UNITED STATES PATENT AND TRADEMARK OFFICE

APPLICATION NO.	FILING DATE	FIRST NAMED INVENTOR	ATTORNEY DOCKET NO.	CONFIRMATION NO.
10/821,173	04/09/2004	Masachika Masuda	123788	8404
25944	7590	10/29/2007	EXAMINER	
OLIFF & BERRIDGE, PLC			KIM, SU C	
P.O. BOX 320850			ART UNIT	
ALEXANDRIA, VA 22320-4850			PAPER NUMBER	
			2823	
			MAIL DATE	
			DELIVERY MODE	
			10/29/2007	
			PAPER

Office Action Summary	Application No.		Applicant(s)	
	10/821,173		MASUDA ET AL.	
	Examiner		Art Unit	
	Su C. Kim		2823

DETAILED ACTION

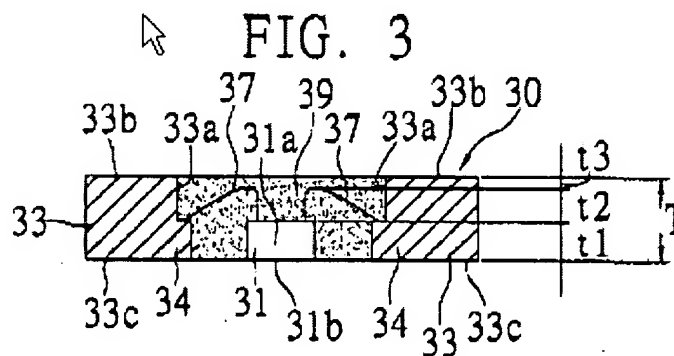
Regarding claim 1, Huang discloses a plastic package comprising:

a plurality of terminal members each having an outer terminal 33b 33 33c (Fig. 3) having an upper surface 33b, a lower surface 33c and an outer side surface 33, an inner terminal having a contact surface 34, and a connecting part connecting the outer and the inner terminal 34 (Fig. 3);

a semiconductor device 31 connected to the contact surfaces 34 of the inner terminals with bond wires 37; and

a resin molding sealing 39 the terminal members, the semiconductor device 31 and the bond wires 37 therein;

wherein the inner terminals 34 of the terminal members are thinner than the outer terminals and have the contact surfaces, the contact surfaces of the inner terminals 34, the upper surfaces of the outer terminals 33b, the lower surfaces of the outer terminals 33c of the terminal members are included in planes, respectively, and the upper 33b, the lower 33c and the outer side 33 surfaces of the outer terminals of the terminal members, and a surface of the semiconductor device 31 opposite the surface provided are exposed outside (Fig. 3), and the inner terminals 34, the bond wires 37, the semiconductor device 31 and the resin molding 39 are included in the thickness of the outer terminals (Fig. 3), and wherein the inner terminal 34 is located closer to the semiconductor device 31 than the outer terminal 33, and the inner terminal 34 has a half-etched (col.5, lines 39-42, inner lead can be formed by using etching) upper surface lower than the upper surface 33b of the outer terminal so that the thickness of the inner terminal is thinner than that of the outer terminal (Fig. 3).

Huang fails to teach the semiconductor device provided with terminal pads, and wherein the semiconductor device has a thickness thinner than that of the inner terminals, and each inner terminal is so constructed that the section of the inner terminal is tapered toward the inside.
